Re: **DYM Tract**

MDP # 039-06

The City Staff Development Review Committee has reviewed DYM Tract Master Development Plan **MDP # 039-06**. Please find enclosed a signed copy for your files. Your plan was approved for acceptance, however please note the following:

**DYM TRACT
MASTER DEVELOPMENT PLAN**

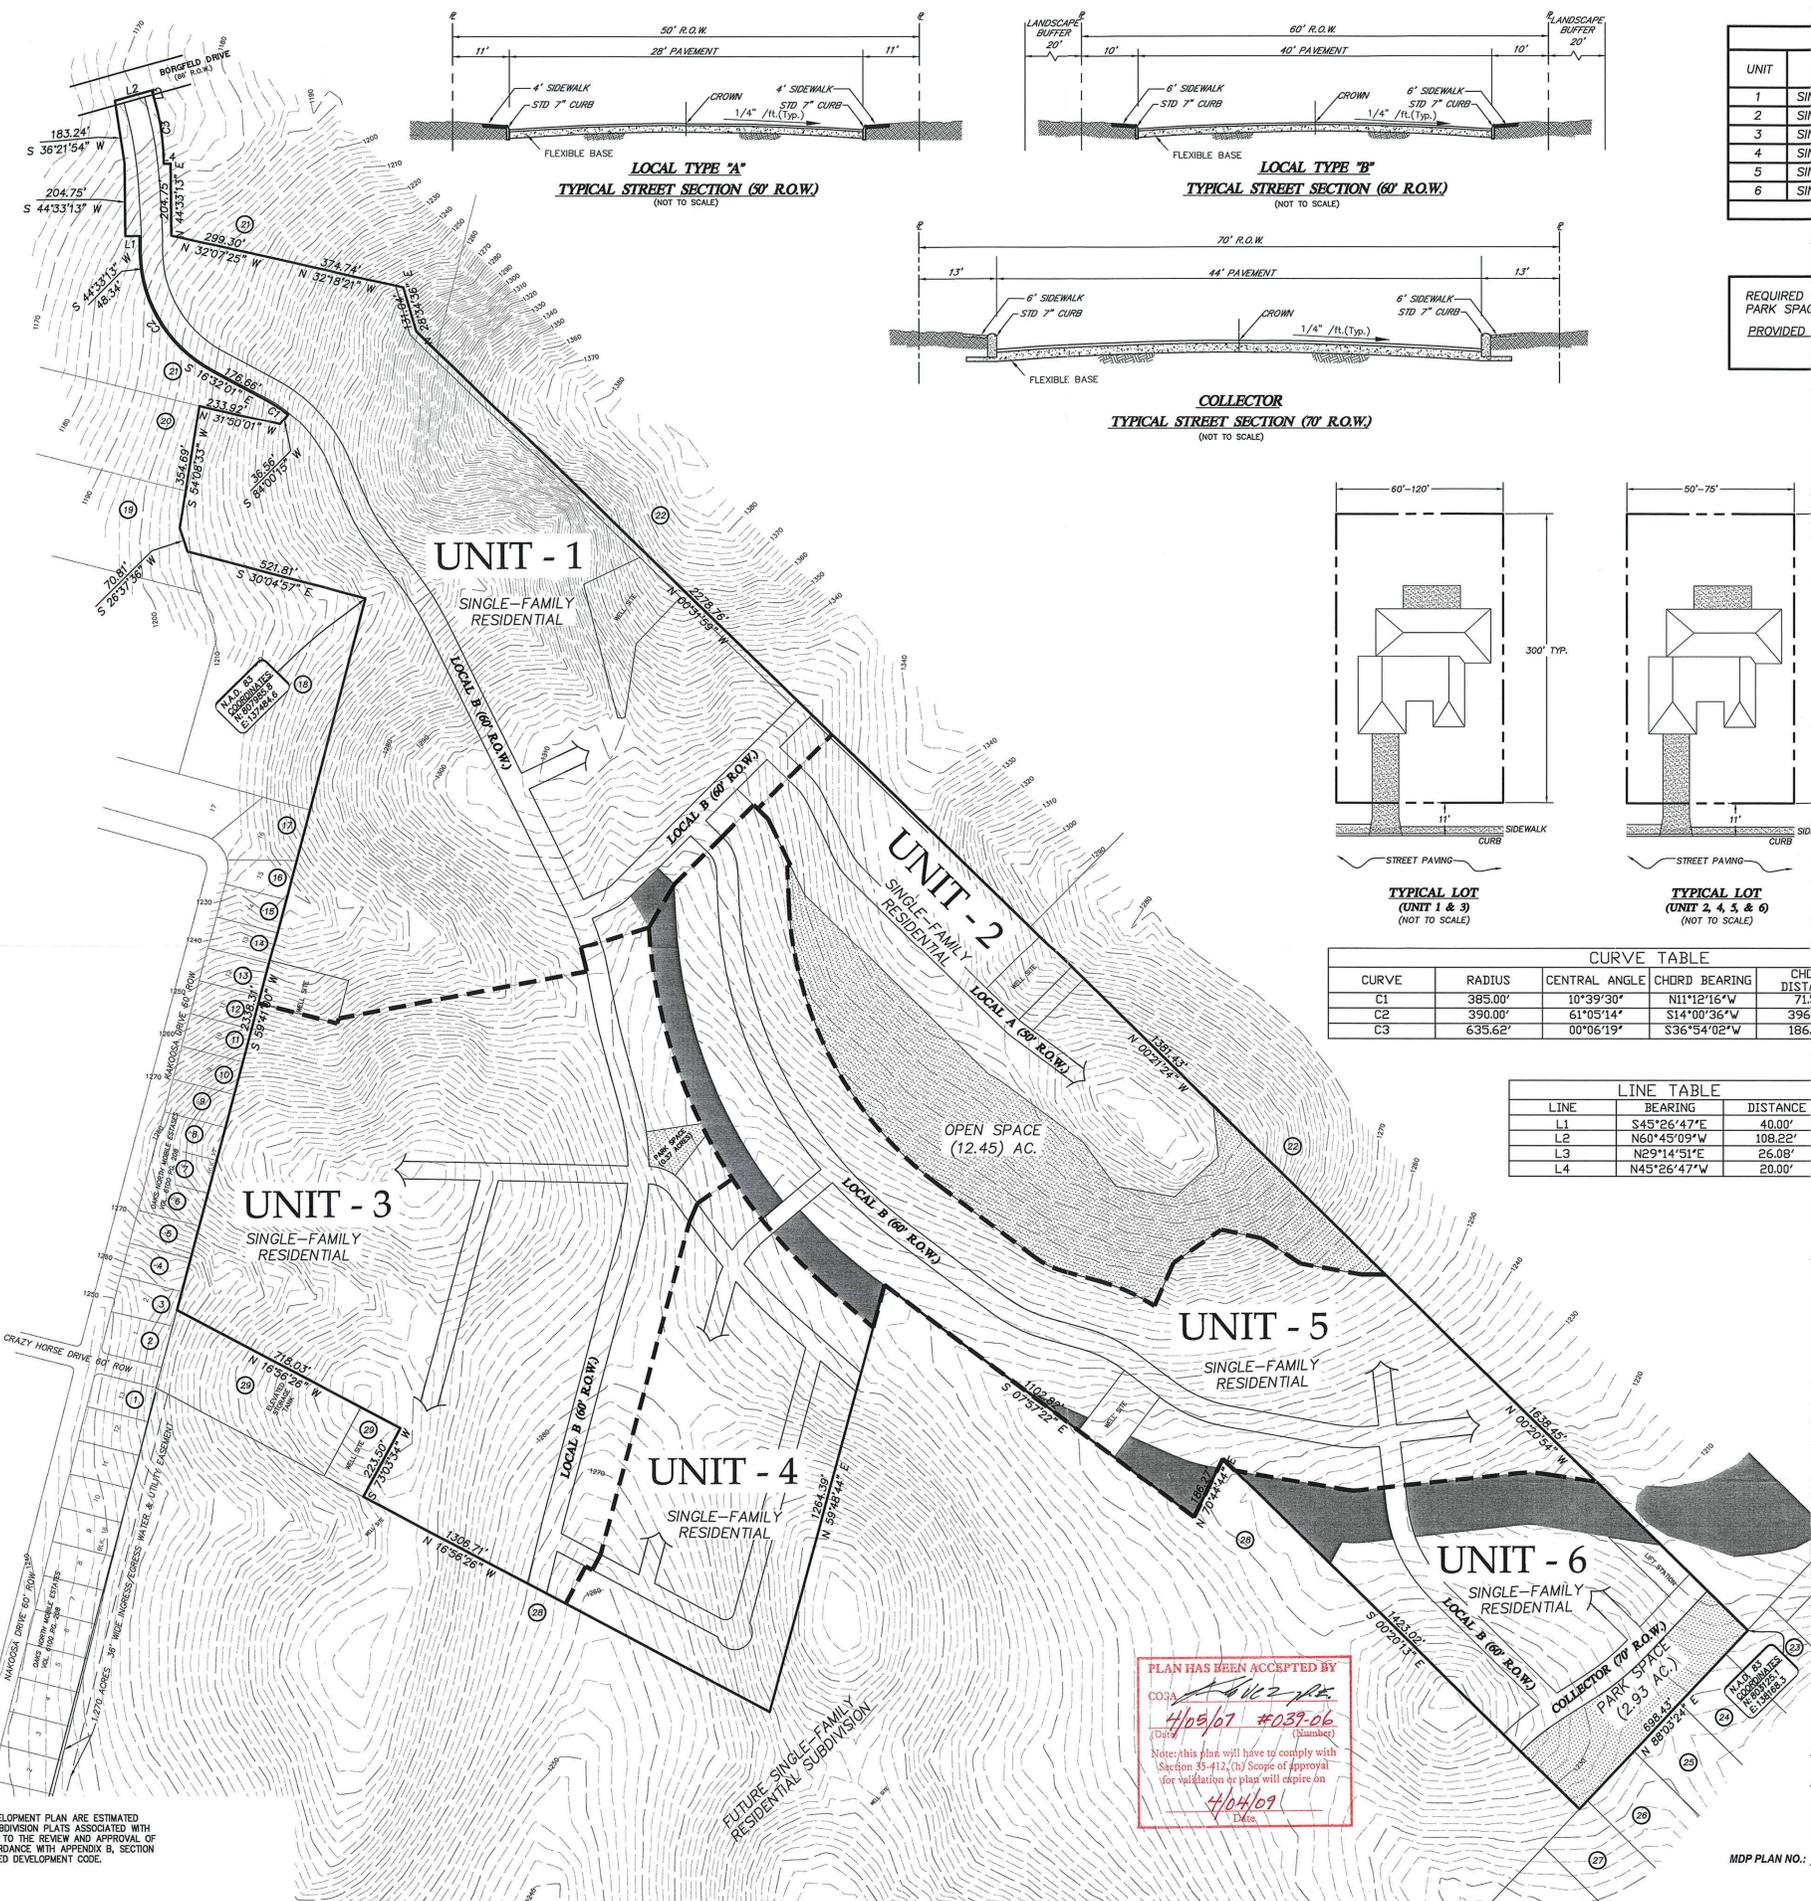
In consideration of public safety and convenience, excessive grades by reason of topography should be avoided in street layouts and arrangements. Any access and R.O.W. issues along state facilities will need to be resolved with the **Texas Department of Transportation (TXDOT)**. For information about these requirements you can contact TXDOT at 615-5814.

SAWS Aquifer Protection and Evaluation will require the following for plat certification:

- 100 year Flood Plain Shown and Buffering (if applicable)
- Sensitive Recharge Features and Buffering (if applicable)
- Category Letter for All Site Specific Plats (if Category 2 or 3, an Aquifer Protection Plan is required)
- Additionally, a Water Pollution Abatement Plan or Contributing Zone Plan must be submitted to and approved by the Texas Commission on Environmental Quality (TCEQ) prior to construction.
- According to the Aquifer Protection Ordinance # 81491, Section 34-913, buffering may be required. The property owner in accordance with SAWS regulations may plug any existing, abandoned or substandard wells found on the site. For plugging procedures please contact Kirk Nixon at 210-233-3523.

- All roadways shall follow Table 506-1, Functional Classification System Description and shall comply with UDC 35-502(a)(9).
- Sidewalks along all interior and exterior roadways are to be installed in accordance with UDC 35-506(q).
- All access roadways shall provide clear sight distance on all existing and proposed roadways in order to provide adequate obstruction free viewing distances for approaching traffic. All signage, landscaping, and improvements shall be selected and located so as to not block these clear sight distance areas.

The developer shall be responsible for providing a left-turn lane, with storage length and bay taper per TXDOT or ASSHTO standards as it relates to the submitted TIA traffic counts, at Borgfield and proposed Local B Street, coordination with Capital Projects at the County will be required for installation of left turn lane -- (UDC)-35-502-(a)(7), subsection C.

Tree Preservation has indicated as part of their approval, the following conditions shall be met:

- 2003 Tree Preservation ordinance standards per UDC Section 35-523 – Tree Permit is required prior to any work on site. This can be submitted either as a clearing permit or at the platting stage or building permit stage. This project appears to be suited to a Tree Stand Delineation (25% preservation of significant trees and 100% preservation of heritage trees) based on the tree canopy area. Note that flood plain area must be delineated separately (preserved at 80% for significant trees and 100% for heritage trees).

DYM Tract is a proposed subdivision with 367 single-family residential units. UDC Section 35-503, Table 503-1 states that single-family development is required to provide 1 acre of park/open space per every 70 dwelling units. The requirement for this development is 5.24 acres. This subdivision provides 3.13 acres of park space dedication (2.93 acres and .2 acres out of a .37 acre tract). In addition, this subdivision will provide a playground for 1.25 acres of credit, a picnic area for .25 acres of credit, and an open play area for 1.0 acres of credit for a total of 5.63 acres of park land dedication.

- The parkland provided shall be shown as “Park” or “Open Space” on a plat; UDC section 35-503(e) *Designation of Parkland*.
- Parkland dedication shall be platted by the second phase of residential development; UDC Section 35-503(f) *Development Phasing*.
- The parkland provided shall be dedicated to the Home Owners Association.

- The instruments creating the Home Owners Association shall be provided by the second application for plat approval; UDC section 35-503(e) *Designation of Parkland*.
- All amenities provided shall comply with standards and specifications found in UDC section 35-503 (h) *Credit for Park Facilities* and Table 503-4 if any credit is to be awarded.

- Secondary access must be secured prior to the approval of any plat or combination of plats exceeding 125 dwelling units as per UDC 35-506(e)(7).
- Coordinate with Bexar County Capital Project Section to include a westbound left-turn lane in the design of Borgfield Road improvement project.
- Traffic control shall be warranted as per the Texas Manual on Unified Control Devices and approved by TXDOT and Bexar County.
